EASTERN CORRIDOR SEGMENTS II AND III (PID 86462)
**US 50 CORRIDOR FOCUS AREA
ADVISORY COMMITTEE MEETING NOTES**

MEETING #3 NOTES

Sept. 7, 2018

Figure 50-5

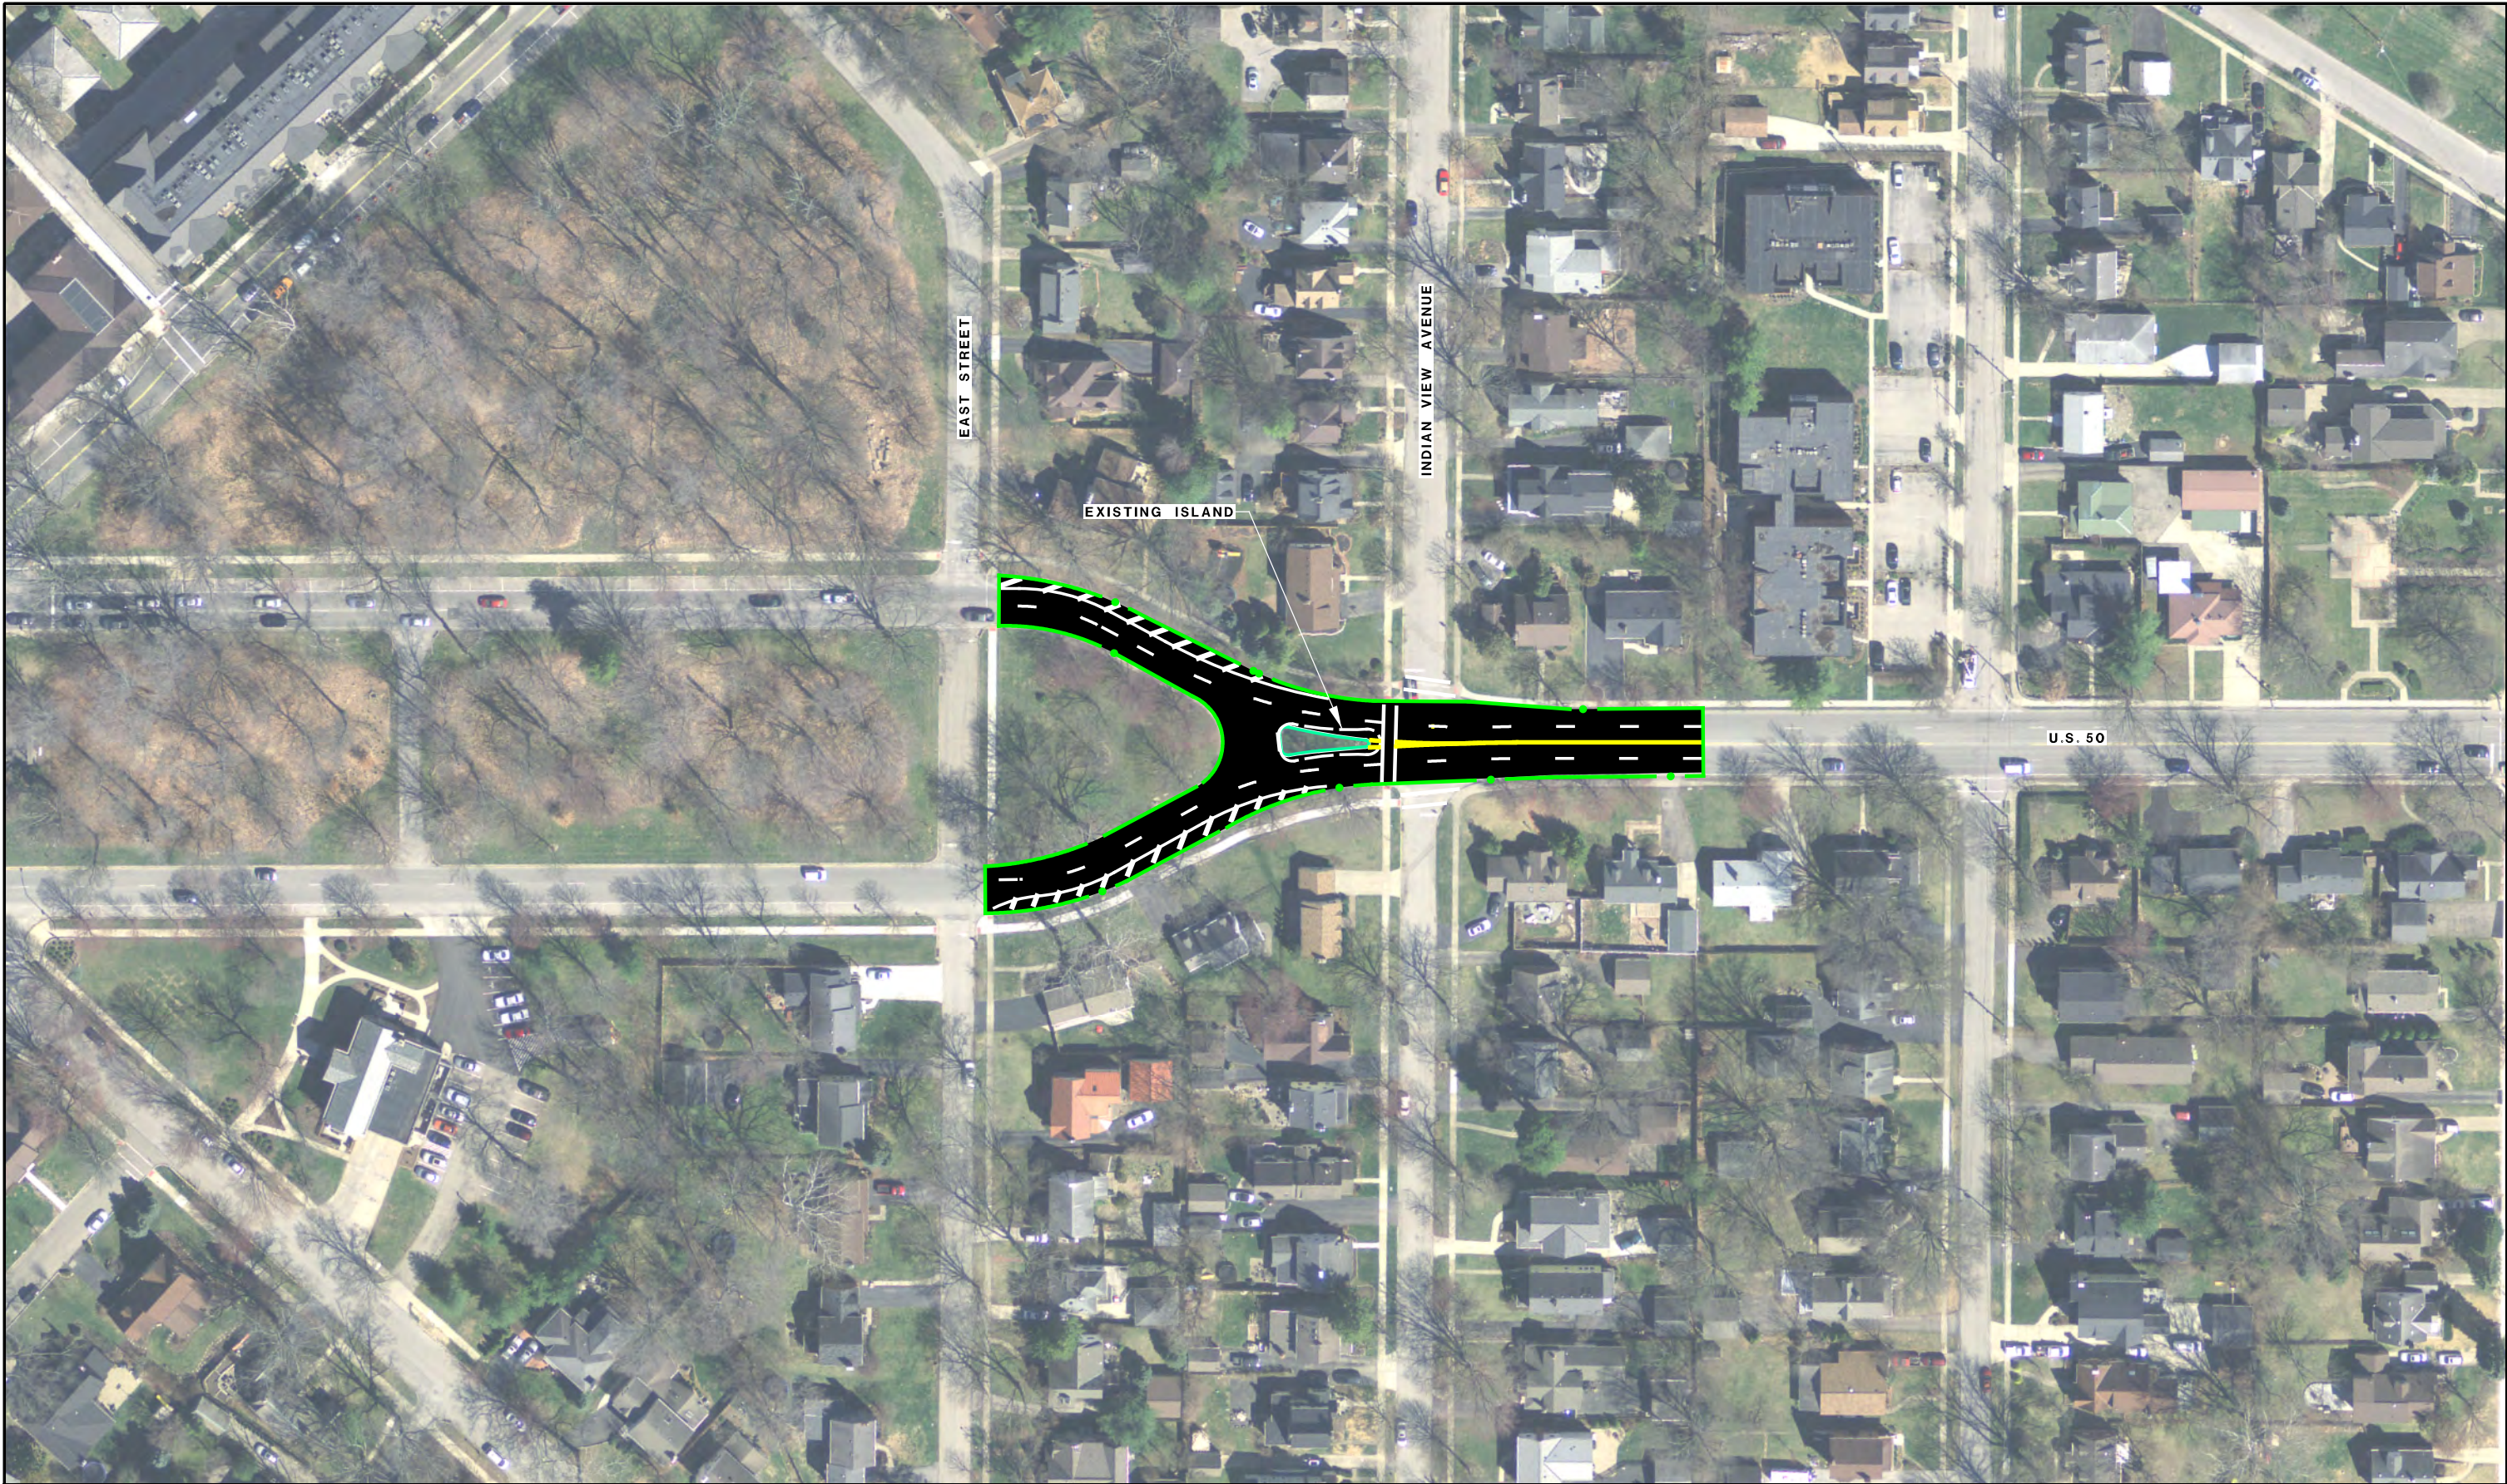
- Mariemont does NOT support widening to two lanes in either direction. Current traffic pattern aids in eastbound and westbound traffic safely accessing side streets on south side of Wooster Pike (US RT 50) and aids in calming traffic as it flows into Mariemont Square where there is a larger concentration of pedestrians and businesses.

Traffic entering Mariemont from the West is not travelling at a high rate of speed. Concept Development Summary matrix provided by ODOT does not accurately depict safety concerns, traffic operations, right-of-way impacts, environmental impacts, and community impacts. The current traffic flow is an important part of John Nolen's design for the Village of Mariemont, a National Historic Landmark community, and should be retained.

- This concept has potential to provide traffic calming and lane utilization benefits farther east, as currently there is poor lane utilization extending back to Pocahontas Ave. Therefore, it has been retained for further consideration.

- To allow enough space for a continuous second lane, the east end of the the traffic island located immediately east of Indian View Avenue would need to be trimmed on its sides by approximately 4 ½ ft. This small modification would only be made to the sides of the island.

- No trees would be affected; the flashing beacon on the island would not be affected; the existing Mariemont sign also appears to be OK, although it may be desirable to shift it back slightly. Note: ODOT recommends shifting both the sign and light for clearance.

- ODOT recommends reducing the speed through this area to 25 mph (potentially extending to Pocahontas Avenue). A speed study would need to be completed before any changes could be made.

- Committee members reiterated concerns about the potential for increased rear-end crashes for drivers turning across traffic onto Indian View Avenue.
- A Mariemont representative requested that the Red Flag Trigger box in the evaluation matrix (see below) be colored red rather than green due to Mariemont's status as a National Historic Landmark. The committee discussed changing the notation to "Requires Section 106 coordination" to help reduce confusion.

- Advance for further study and possible inclusion in ODOT 2019 resurfacing project (PID 101309). ODOT is initiating Section 106 Coordination and speed study to extend the 25 mph speed to the east corp. limit.

Figure I-11C
ROUNDAABOUT AT NEWTOWN ROAD
AND WOOSTER PIKE INTERSECTION

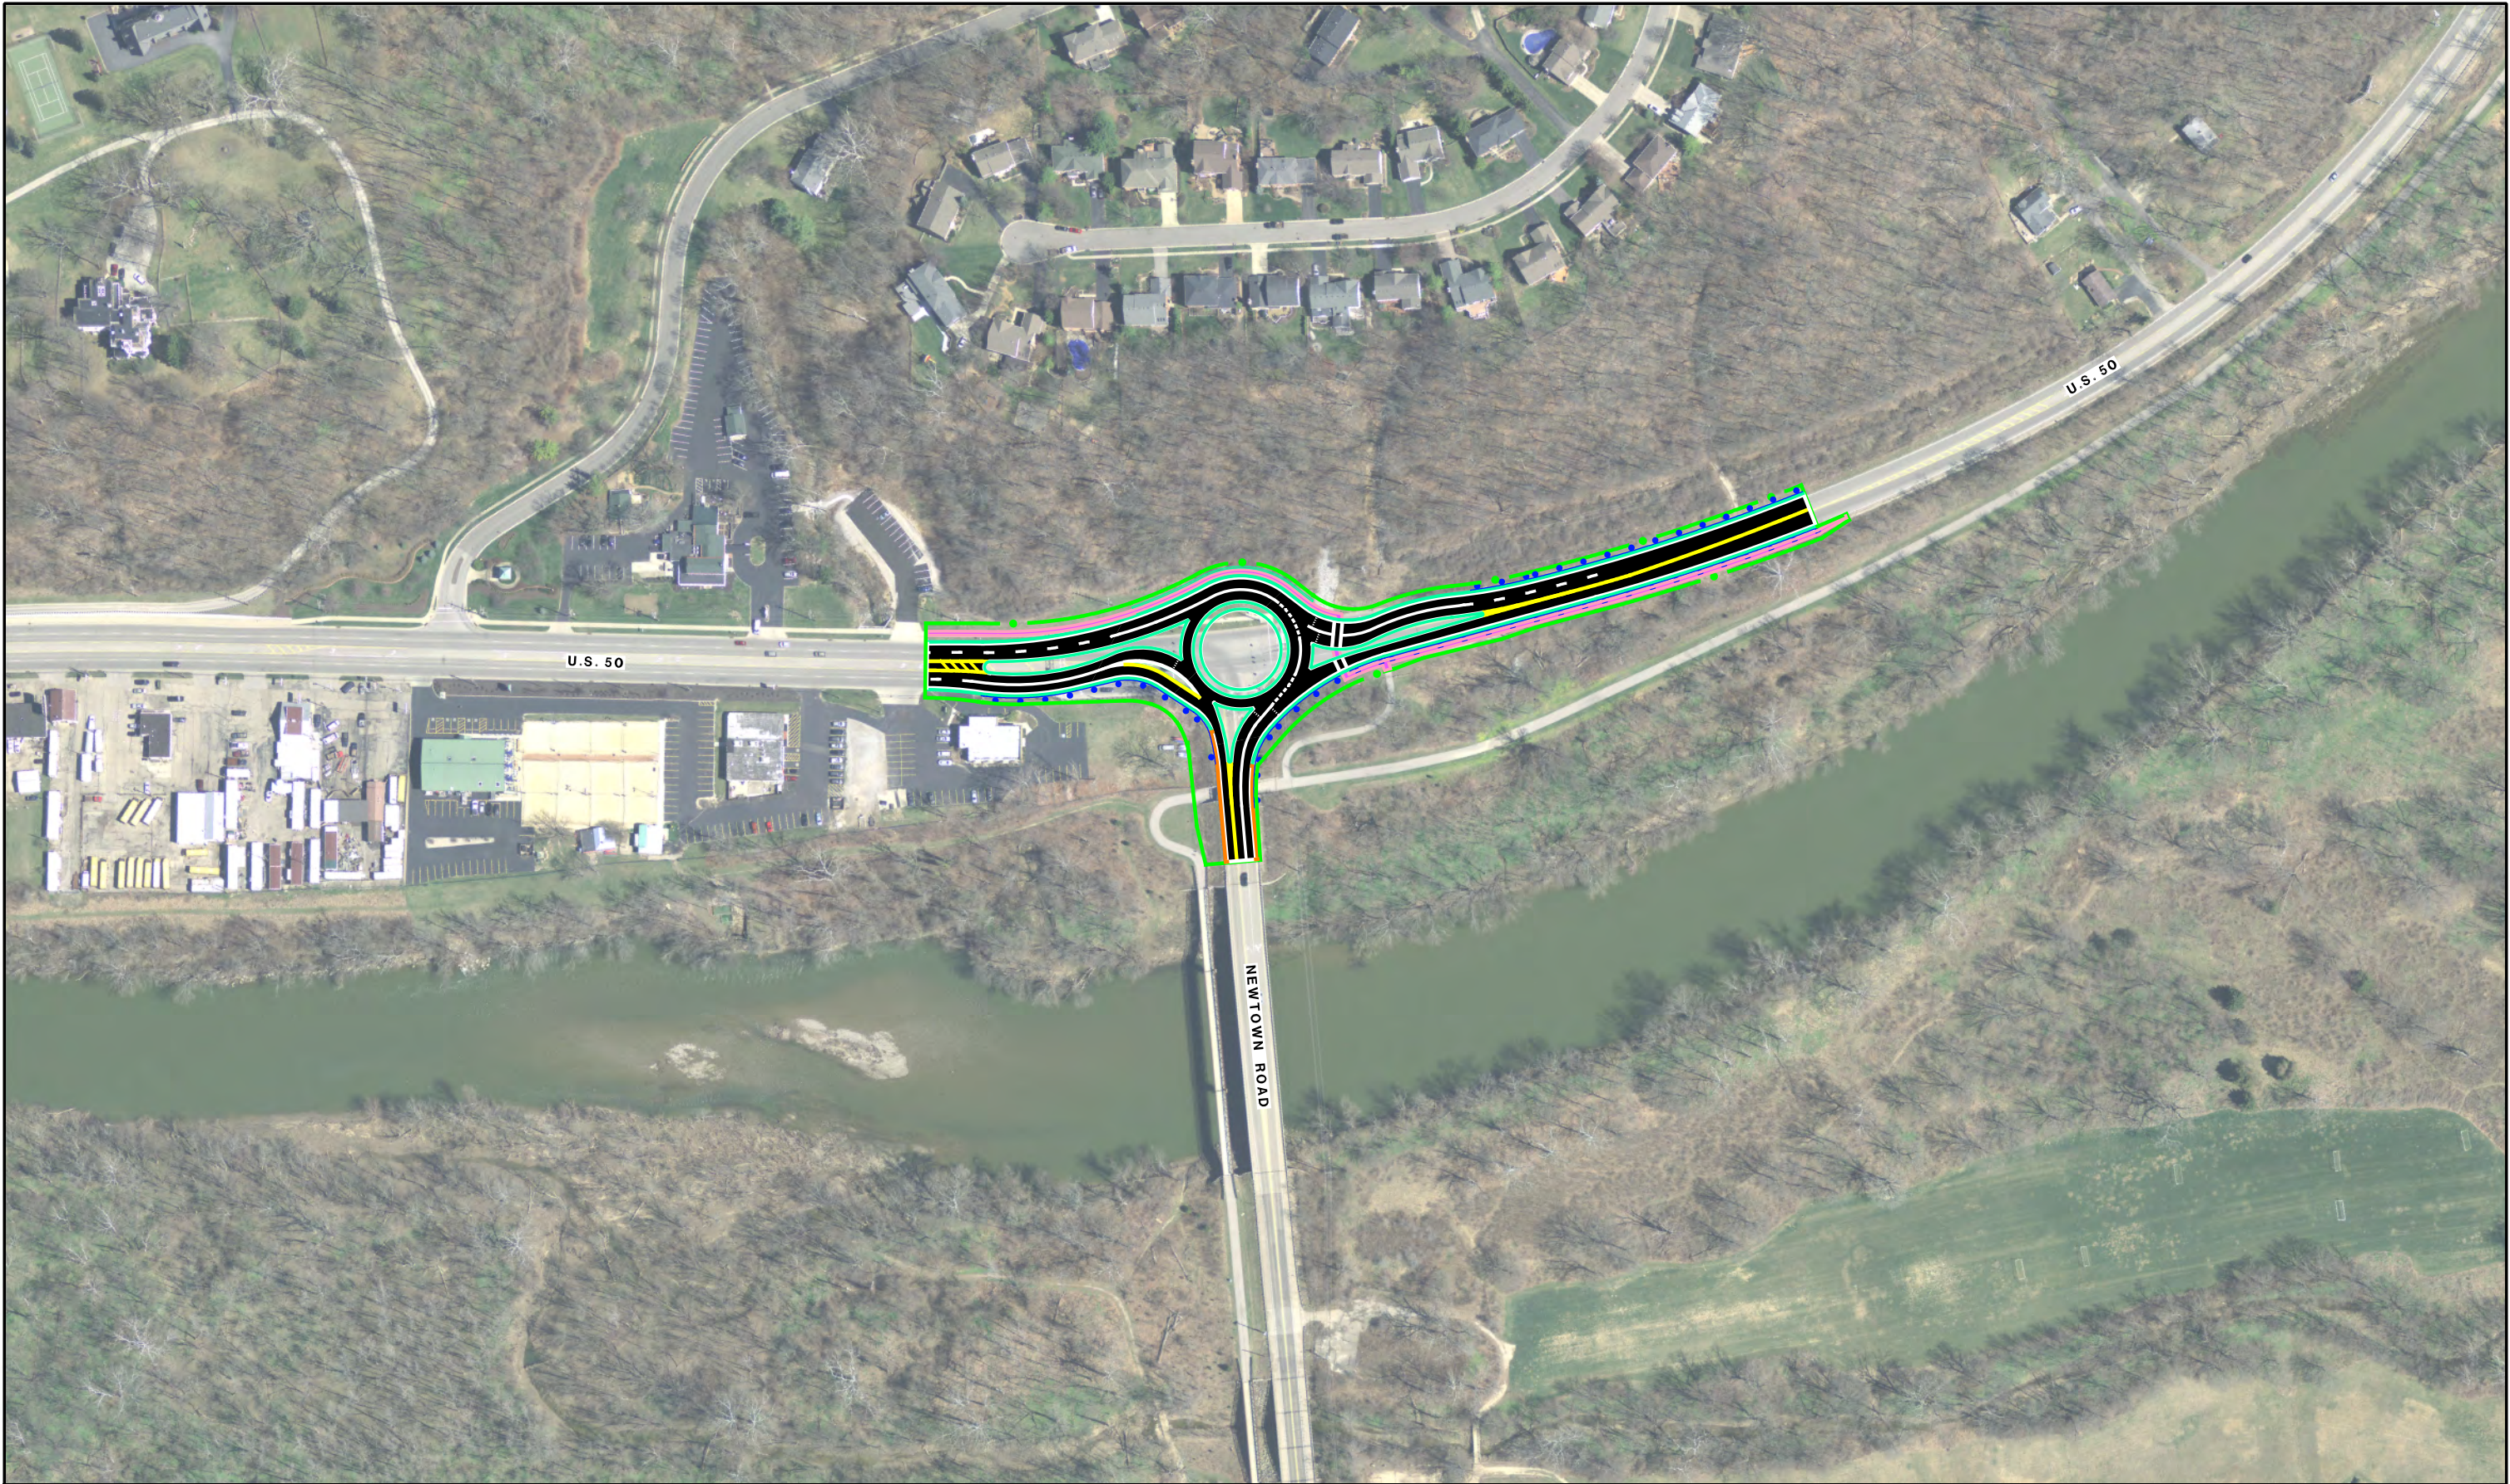
- Major traffic flow change will require community input. ODOT needs to verify Figure I-11c is drawn to scale and is sized to allow trucks and life-safety equipment adequate clearance/passage through the roundabout.

- US 50 is four lanes in this point and can handle a constant stream of dual left turns from Newtown Road to US 50 generated by the roundabout.
- Roundabouts have the added benefit of calming traffic, providing easier access and improving safety in addition to serving as a gateway feature.
- The roundabout can accommodate fire trucks and semi trucks.

- Advance for public consideration.
